DOCKETED		
Docket Number:	24-OPT-04	
Project Title:	Potentia-Viridi Battery Energy Storage System	
TN #:	265208	
Document Title:	Biological Resources Responses to CEC Emails	
Description:	Includes responses to the CEC's request and includes the following attachments: Civil Plans, Revised LSAA Application, Redlined LSAA Application, Field Forms, Resumes, Biological Opinion	
Filer:	Ronelle Candia	
Organization:	Dudek	
Submitter Role:	Applicant Consultant	
Submission Date:	8/1/2025 2:04:20 PM	
Docketed Date:	8/1/2025

CEC Data Request - Biological Resources Follow-Up Response

Potentia-Viridi Battery Energy Storage Project

POTENTIA-VIRIDI BATTERY ENERGY STORAGE SYSTEM

CONCEPTUAL CIVIL **HYDROLOGY HYDRAULIC** OUTFALL **SCHEMATIC**

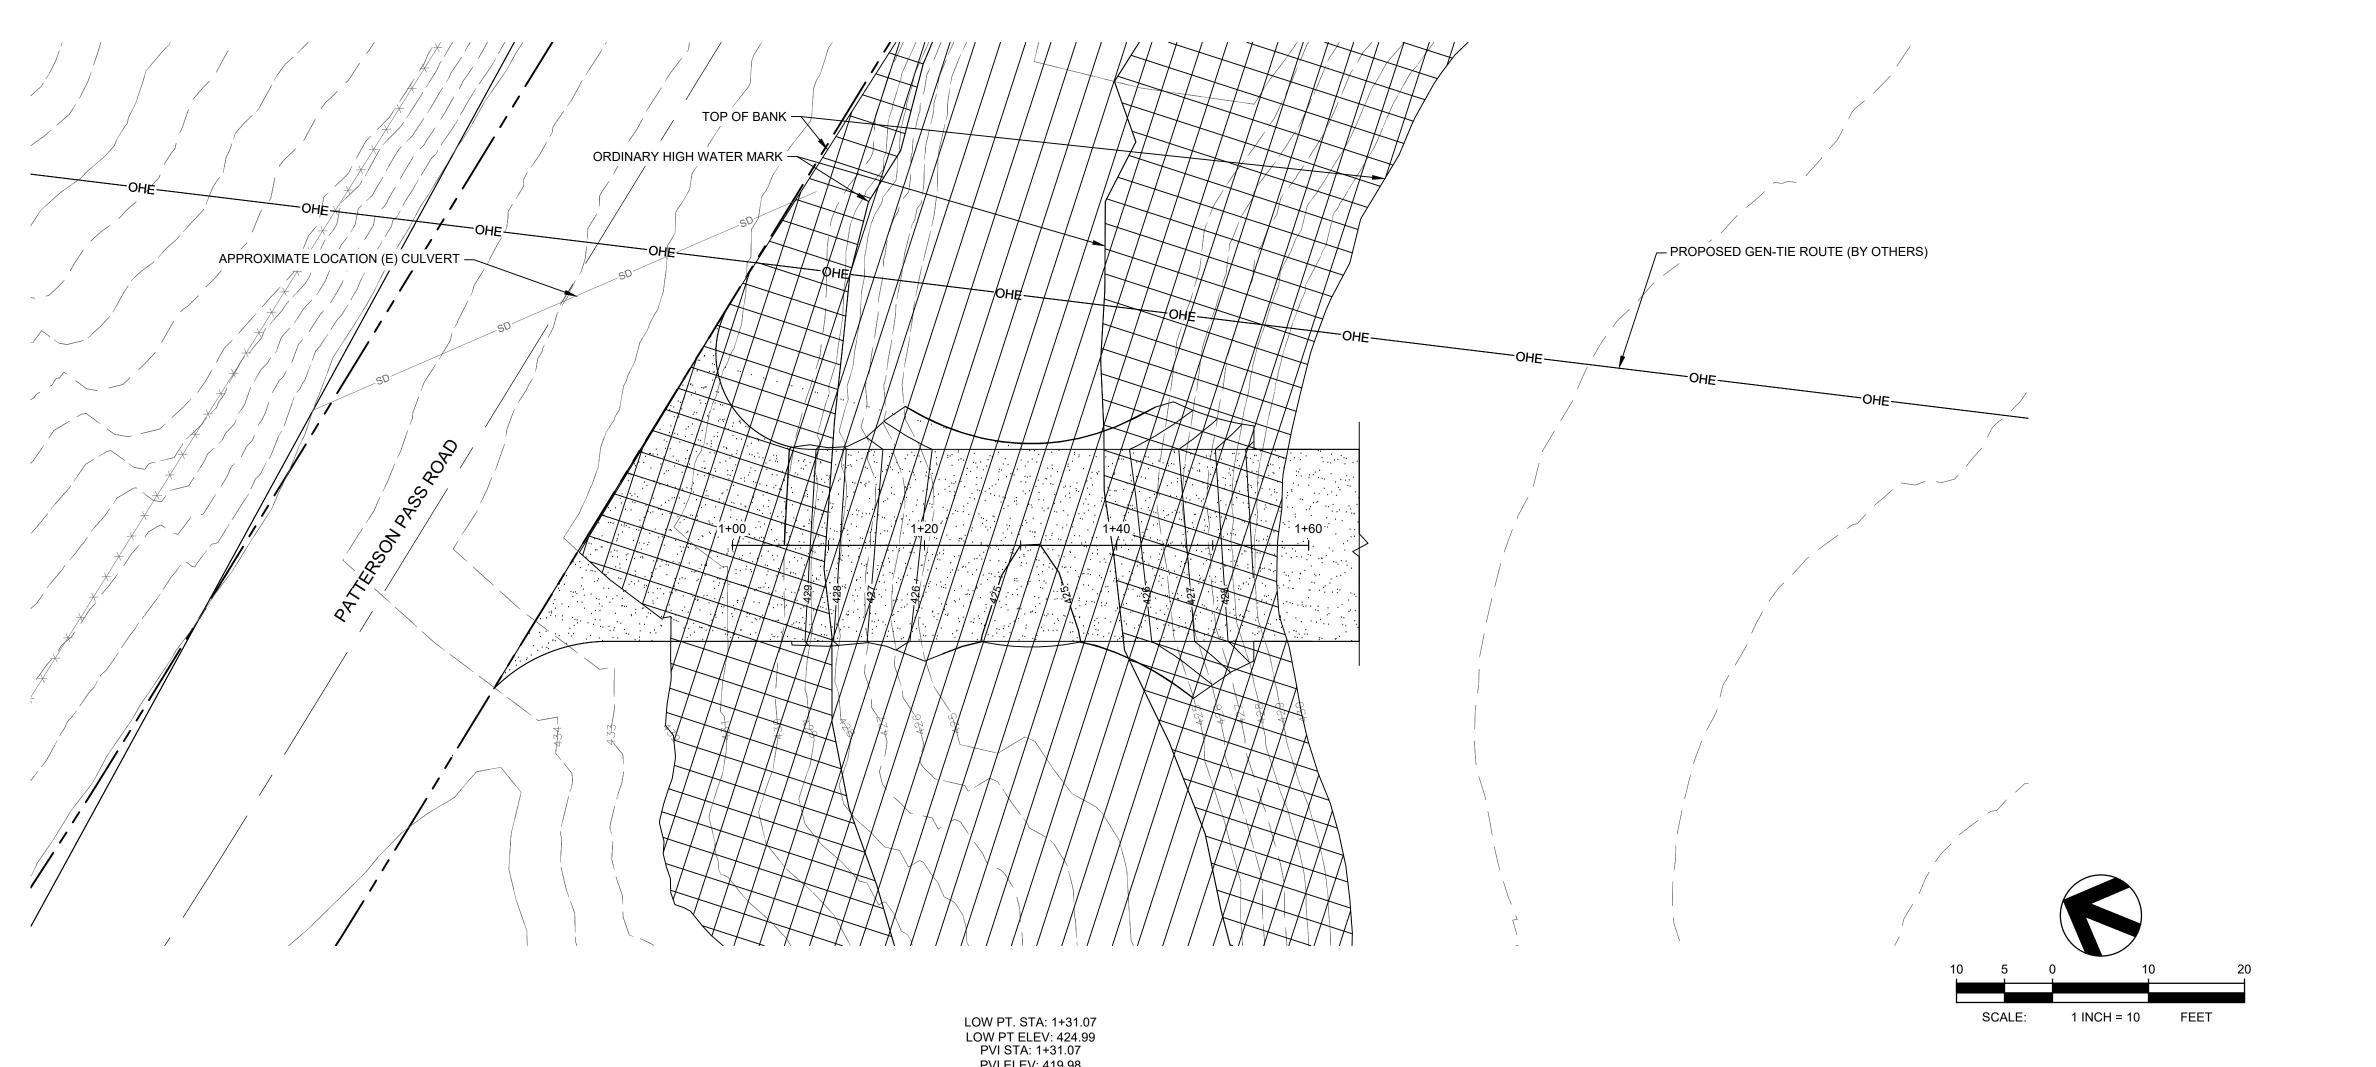
DR 1. California Department of Fish and Wildlife has completed review of the "401 Permit Figures" that you docketed (Ref. TN 264903) on 7/18/25. CDFW is requesting expansion of the area of CDFW regulatory authority to elevation 432 on the west side of Patterson Run creek and to 430 on the east. Please revise the plans to reflect CDFW jurisdictional area and provide updated impact estimates in the LSAA notification. Please revise the LSAA notification and re-submit a redline/strike-through version, to include the .kmz files.

Response: CDFW's jurisdictional area has been revised to the elevations requested and the figures have been updated accordingly and uploaded to the Docket (Attachment 1, Civil Plans). In addition, the LSAA notification has been revised and both the revised application (Attachment 2, Revised LSAA Application) and a redline/strikeout version (Attachment 3, Redlined LSAA Application) have been uploaded to the Docket. The .kmz files have been emailed directly to Mr. Eric Veerkamp for distribution.
